TSB # 15-2017

TO: All Bourgault Dealers  
ATTN: Service Manager, Parts Manager, Sales Manager  
SUBJECT: "Rapid Opener Drop" – change to Counter-Balance Cartridge

## INFORMATION BULLETIN:

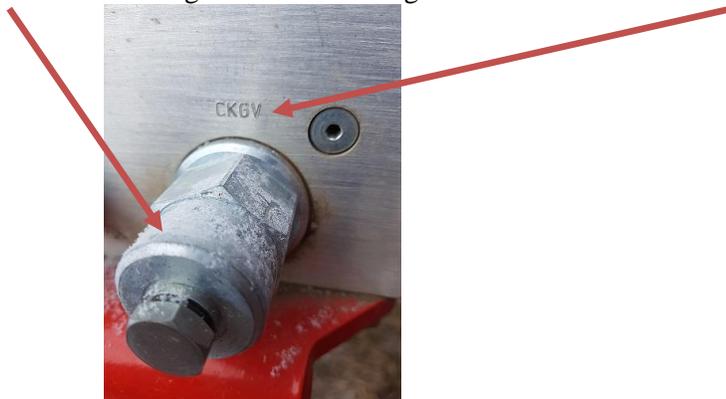
All model year 2017, 3320 and 3720 drills have been built with a counter-balance cartridge instead of the previously used PO check-valve cartridge. This change will allow the system to withstand a higher system imbalance (caused by the combination of opener cylinder bypass and air trapped in the system) before the drill experiences the rapid opener drop situation. Of course this new cartridge will have a limit to how much of a system imbalance it can withstand before opening and at that point any opener cylinders with internal bypass will need to be repaired or replaced and steps taken to remove the excess air trapped in the system.

Any 3310, 3320, 3710 or 3720 drills, experiencing the rapid opener drop situation may benefit from replacing the PO check-valve cartridge with this new counter-balance cartridge to extend transport range prior to having to repair or replace bypassing opener cylinders. The new counter-balance cartridge will not resolve slow opener drop concerns.

- Remove the existing PO Check-Valve cartridge from the existing block. The block will be stamped CKGV.

- Install the new cartridge (3441-21-08) into the CKGV port stamped on the hydraulic block.
- This fix can be applied to units with a high float block or a standard block.
